To: T10 Technical Committee
From: Rob Elliott, HP (elliott@hp.com)
Date: 10 September 2002
Subject: T10/02-360r0 SAS spin-up

Overview

This state diagram shows how the target interprets the SPINUP primitive and the START STOP UNIT command requesting either START or STOP:

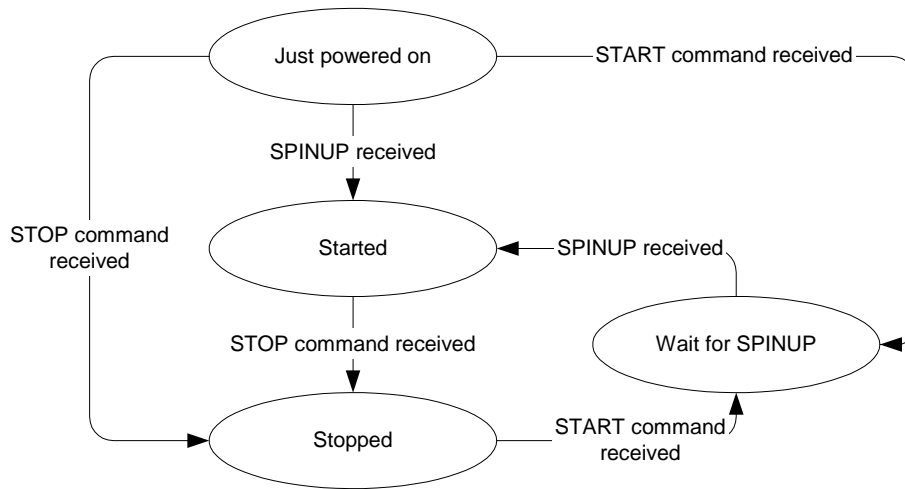
Create a new SPINUP primitive. Immediately after power on, it is used to trigger automatic spin-up; afterwards, it interacts with the START STOP UNIT command to delay when software-requested spin-up actually occurs.

- a) after power on, if the drive has not received a STOP from software, spin-up automatically;
- b) after power on, if the drive has received a STOP from software with a subsequent START, spin-up. Software's START request is effectively delayed until the SPINUP arrives;

c) after power on, if the drive has received a STOP from software without a subsequent START, do nothing (only SPINUPs before the first STOP automatically cause spin-up).
